2706477	Summit Homes - Reserve at Stoney Creek #87	TBD	Lee's Summit, MO	SCOTT CLEVENGER	4/5/2021
JOB No.	DESCRIPTION	JOB ADDRESS	CITY	DESIGNER	DATE

ROOF TRUSS LAYOUT

SIDENTIAL ENGINEERING SERVICES, LLC SHOP DRAWINGS/SUBMITTAL REVIEW

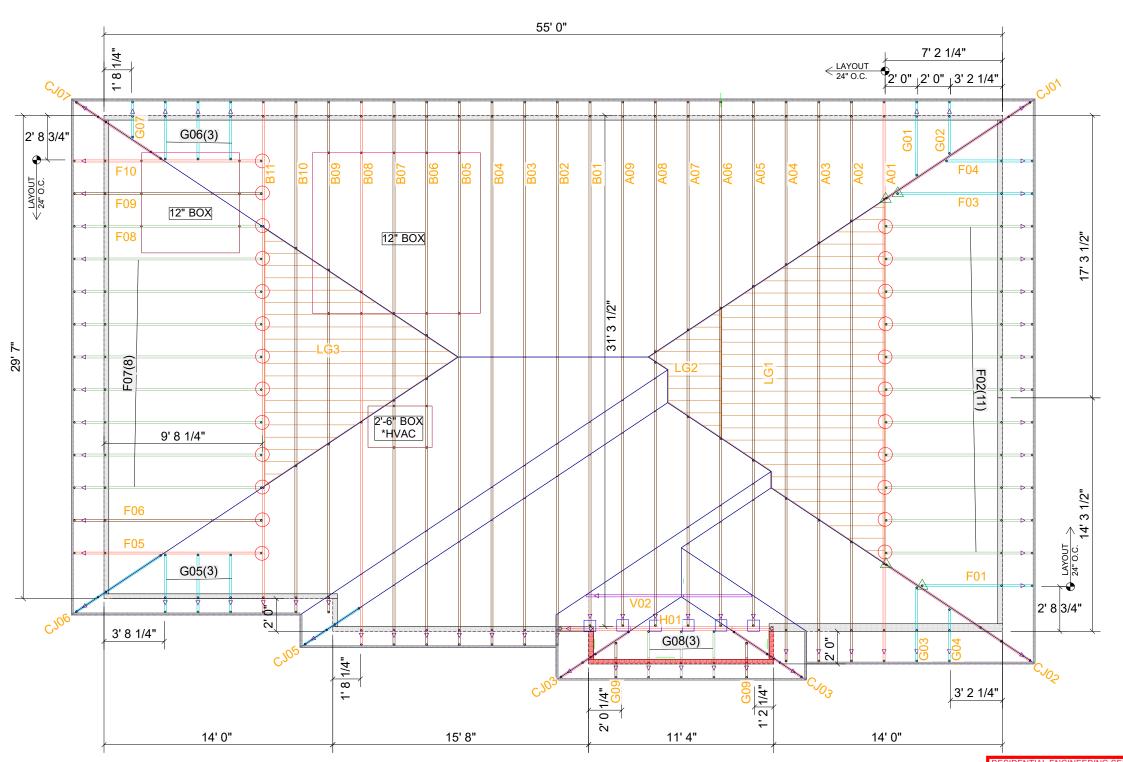
SUBMITTAL WAS REVIEWED FOR DESIGN CONFORMITY AND GENERAL CONFORMANCE TO CONTRACT DOCUMENTS ONLY. THE CONTRACTOR IS RESPONSIBLE FOR CONFIRMING AND CORRELATING DIMENSIONS AT JOBSITE FOR TOLERANCE, CLEARANCE, QUANTITIES, FABRICATION, COORDINATION OF HIS OR HER WORK WITH OTHER TRADES, AND FULL COMPLIANCE WITH CONTRACT DOCUMENTS. CONTRACT DOCUMENTS.

STATUS

APPROVED
